**Blackmoorfoot Road, Huddersfield
Proposed Access Arrangements
Stage 1 Road Safety Audit**

May 2025 (Rev 1)

Miller Homes & Vistry Homes Limited

FILE GENERAL ARRANGEMENT OF S278 WORKS FOR OUTLINE AGREEMENT

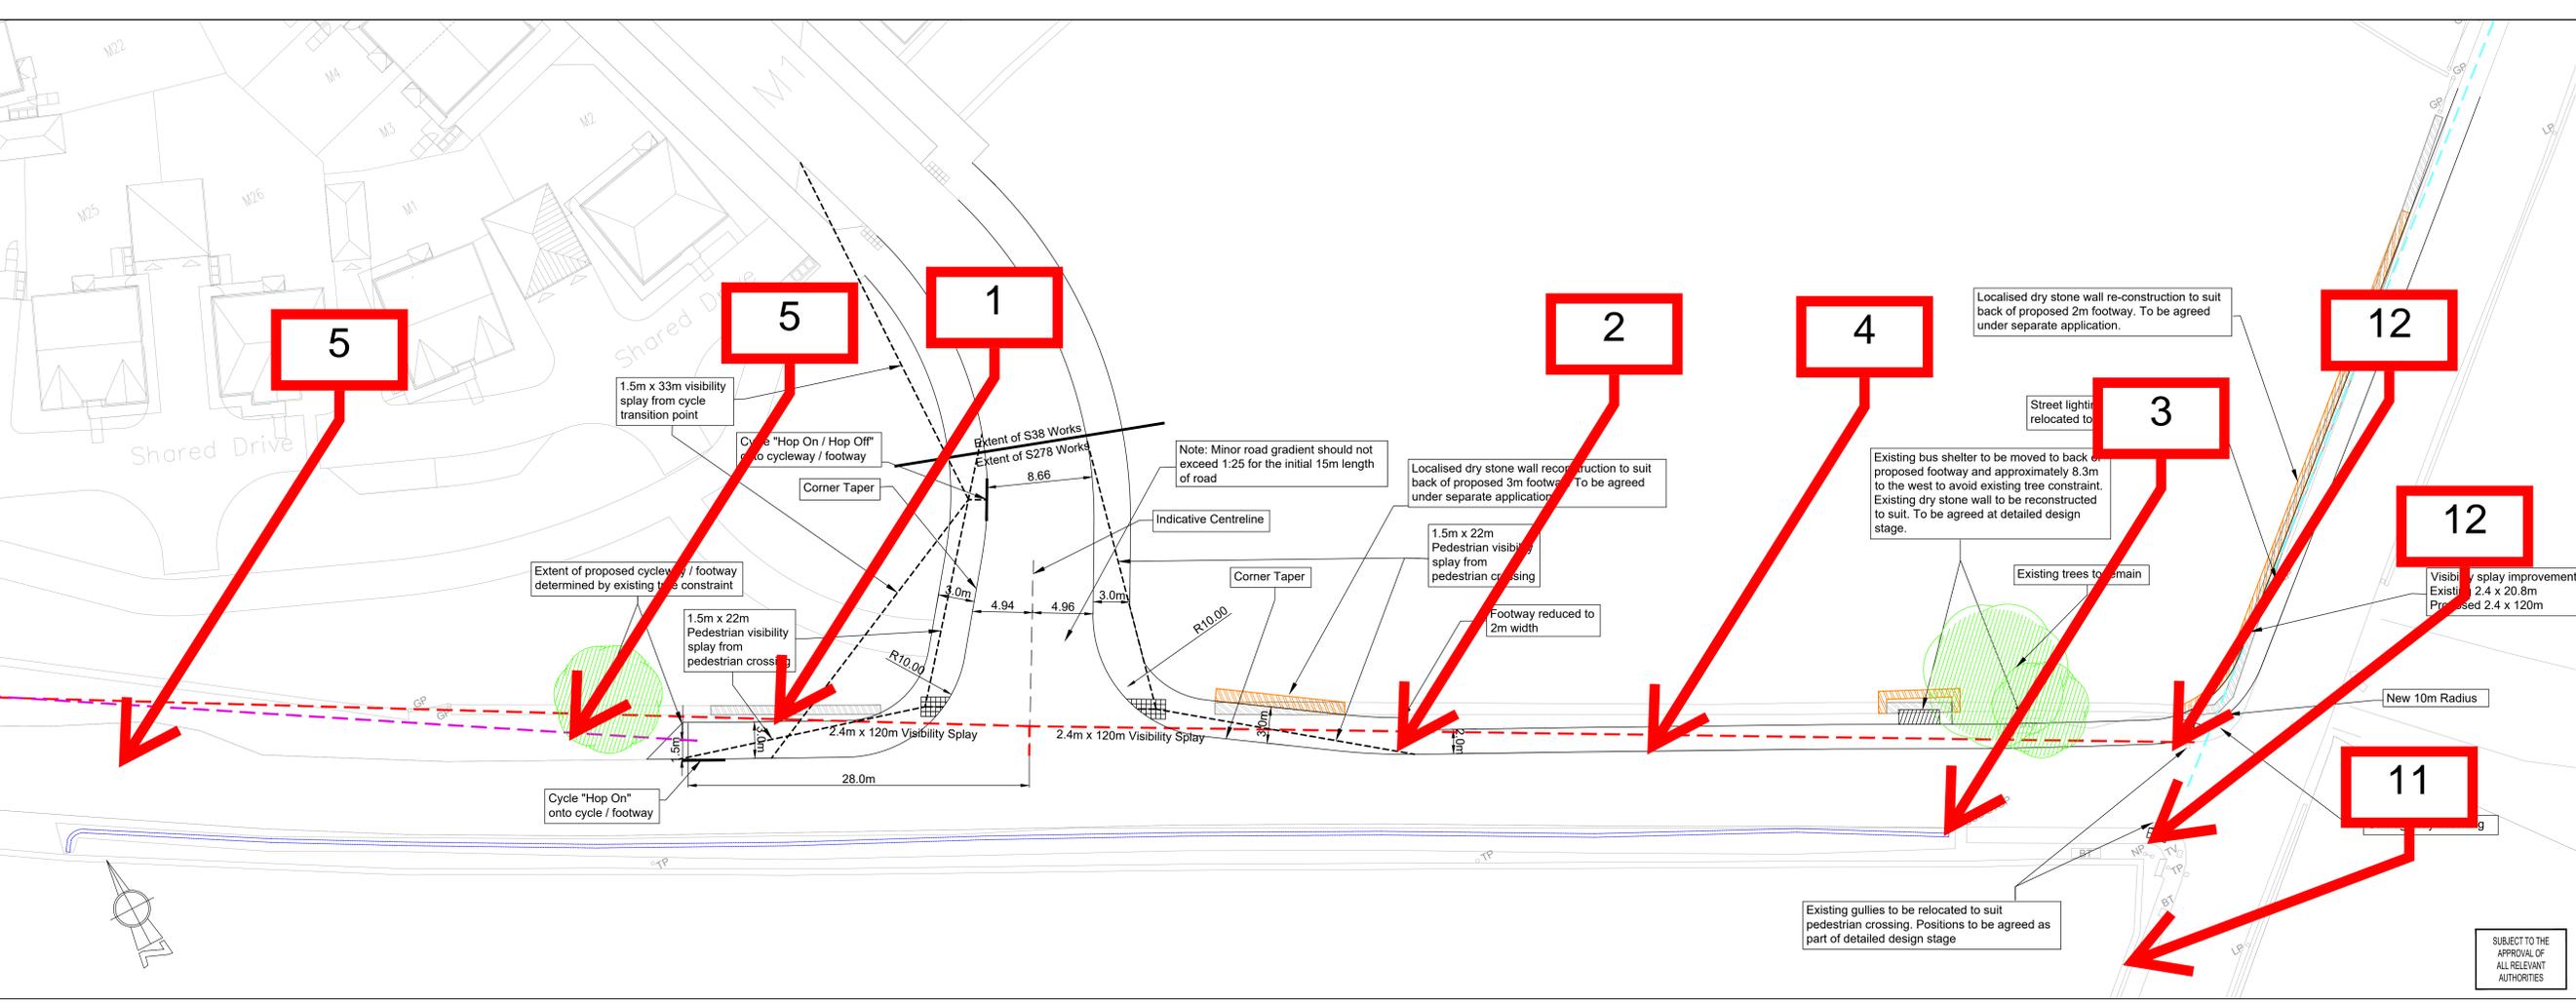
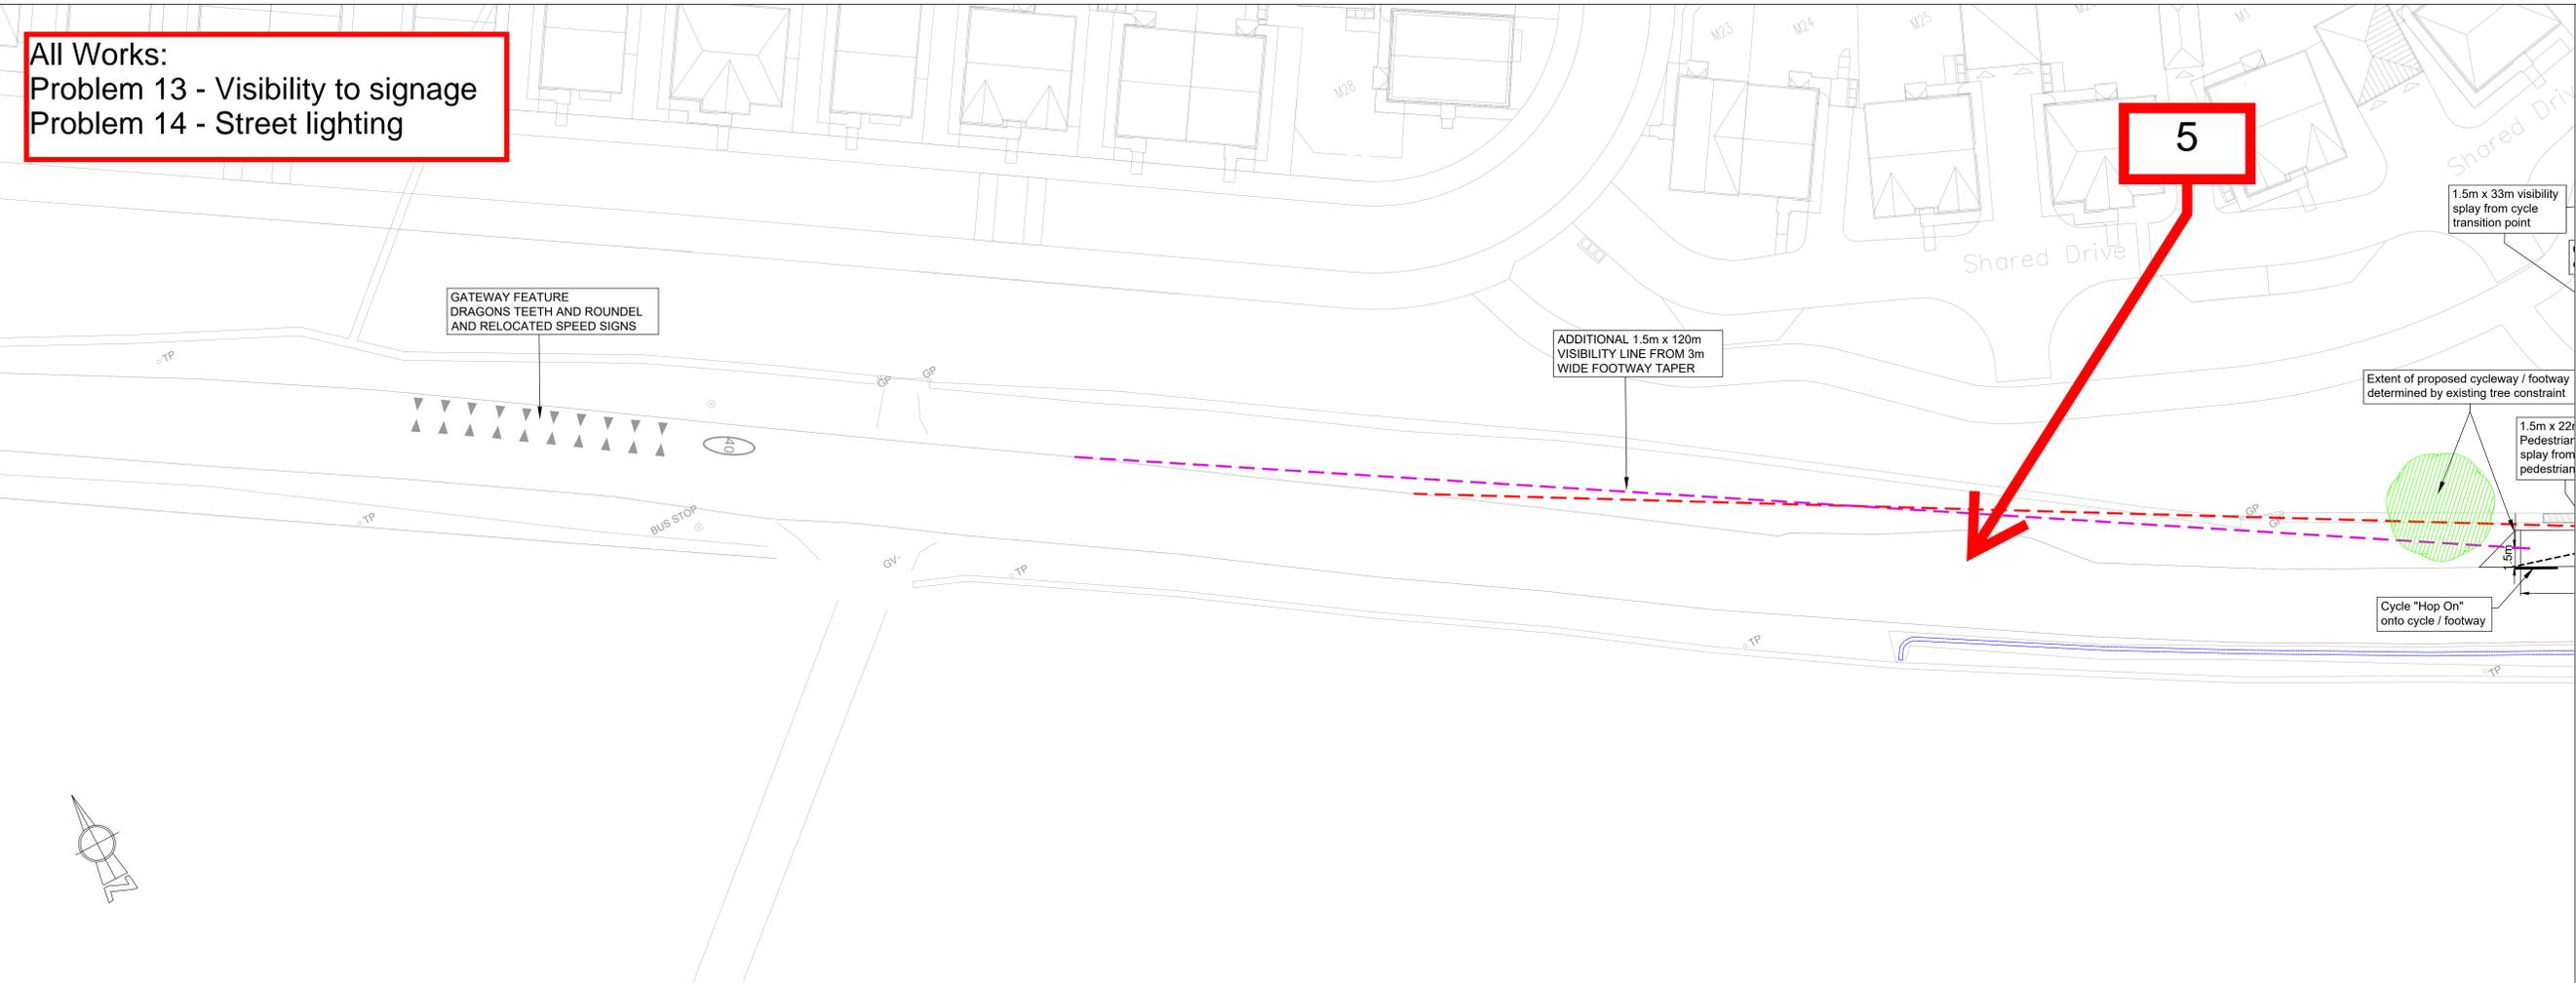
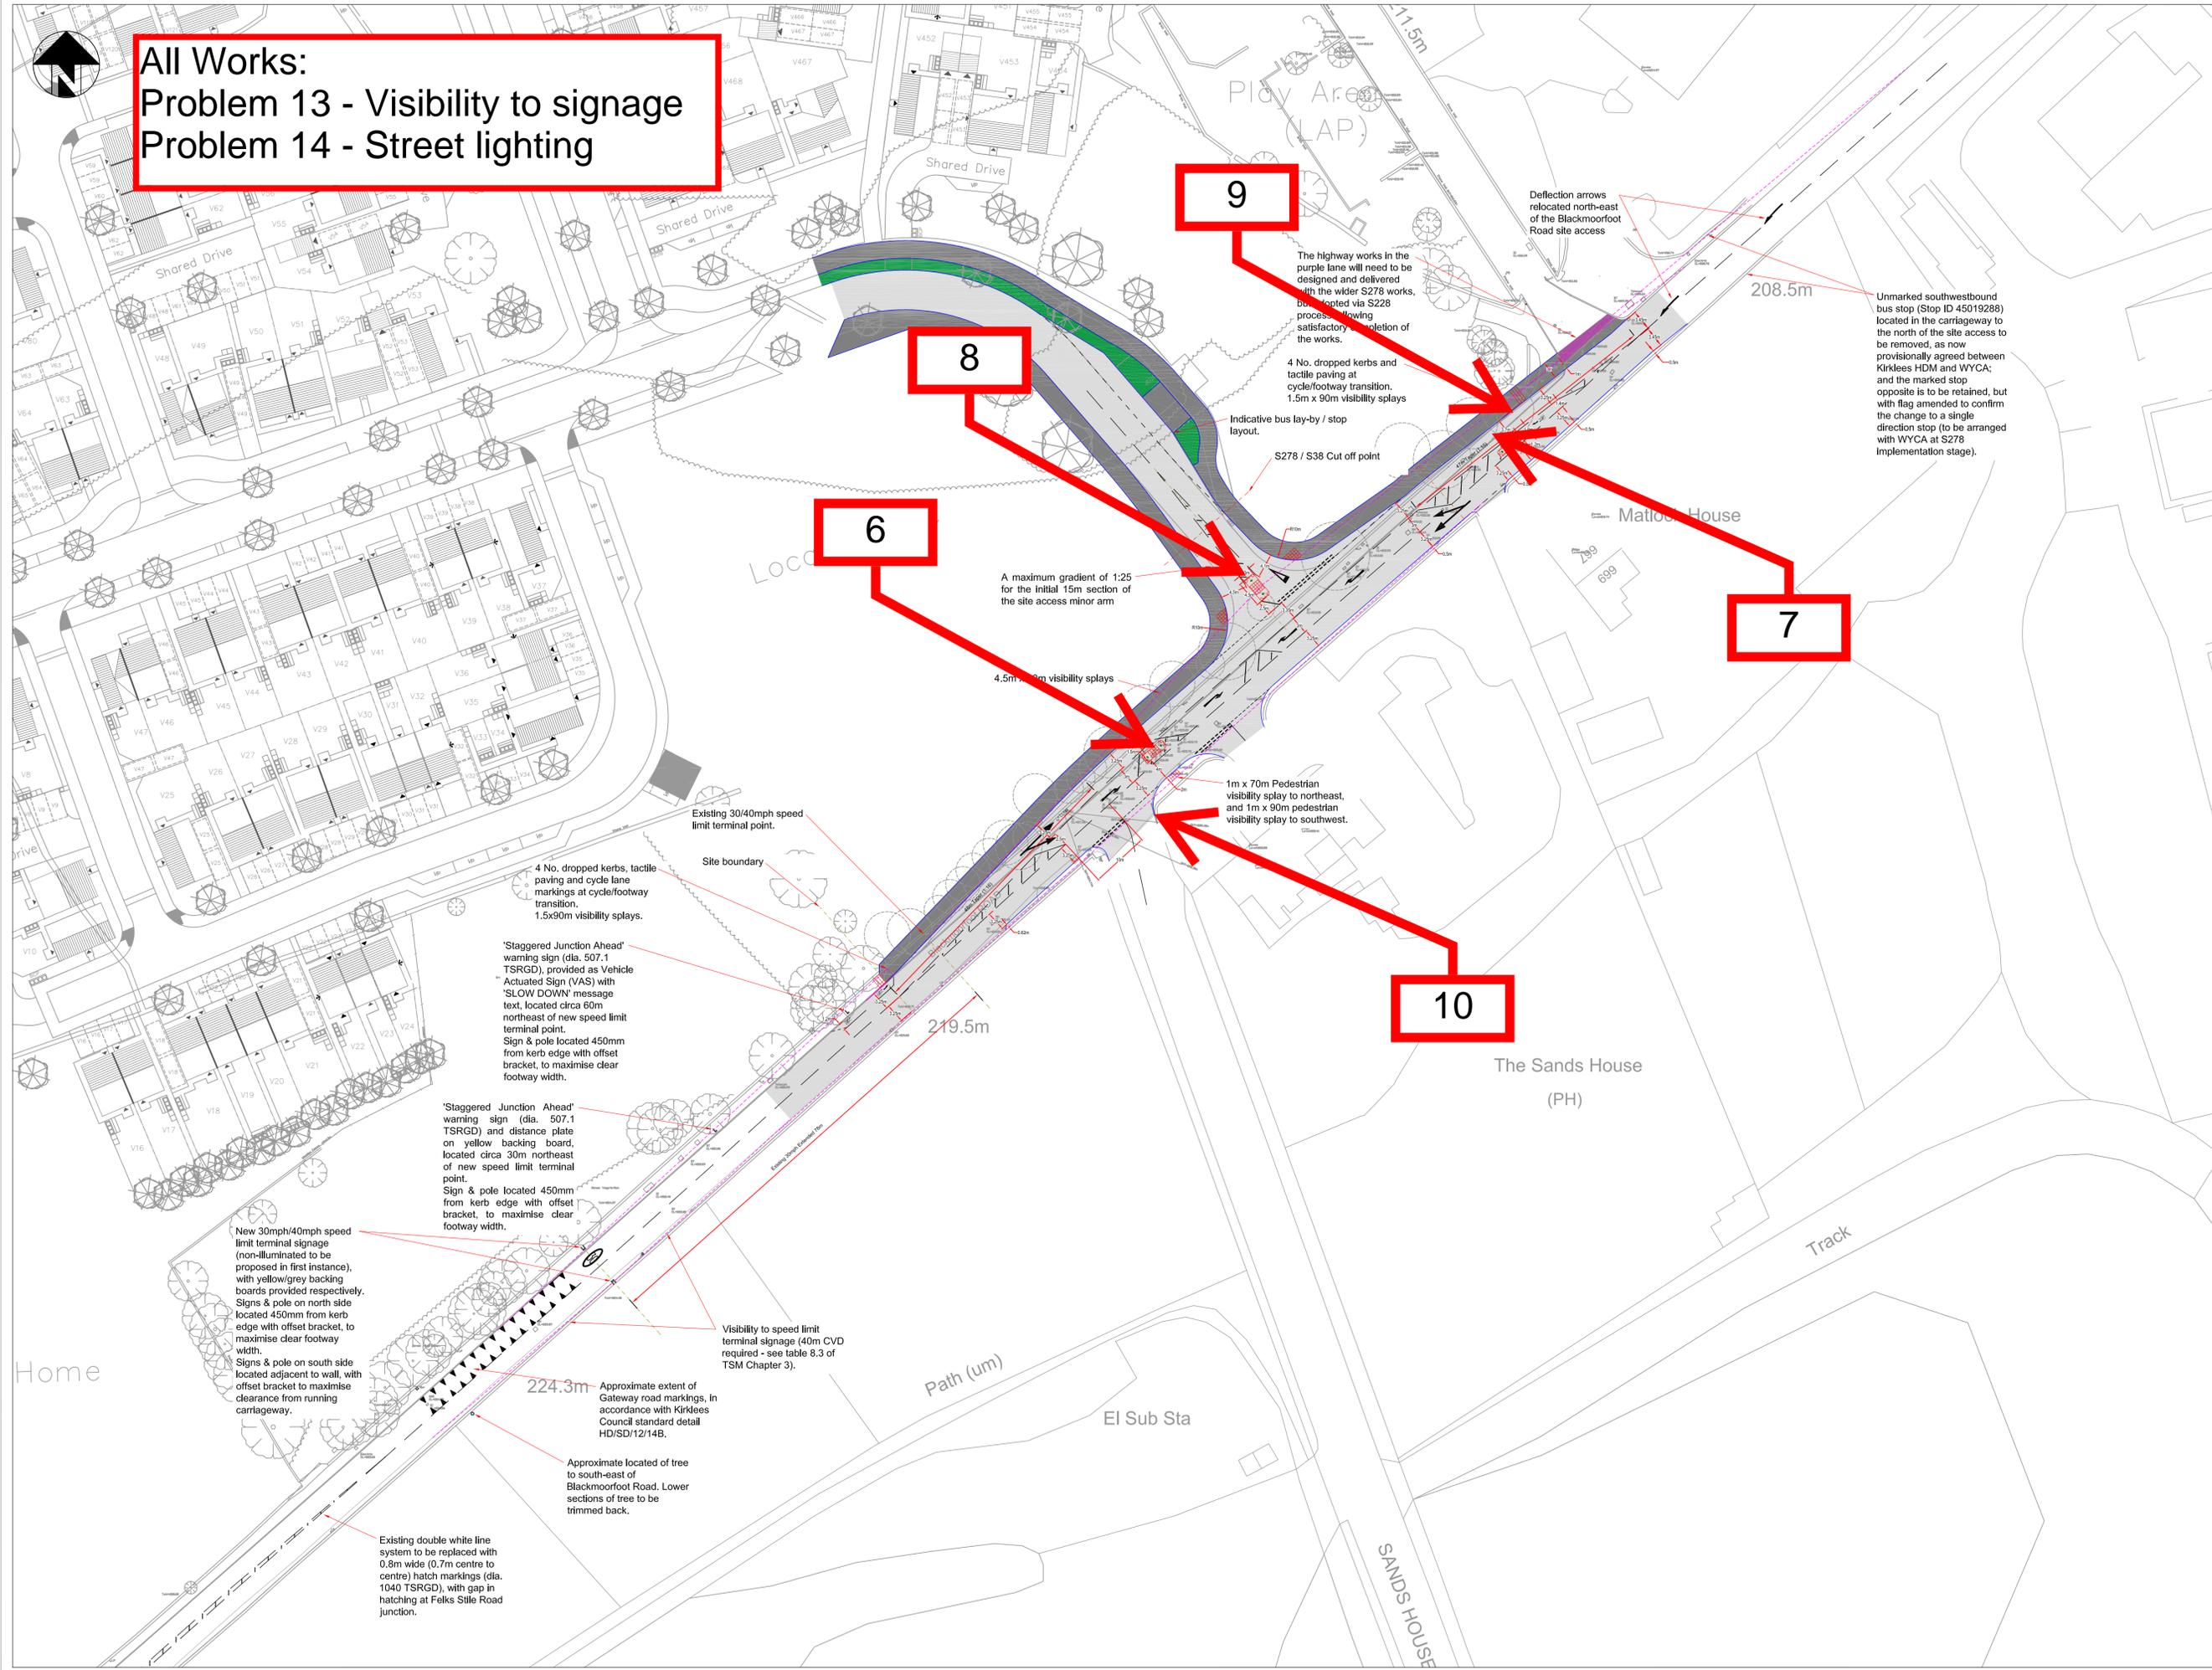
All Works:
 Problem 13 - Visibility to signage
 Problem 14 - Street lighting
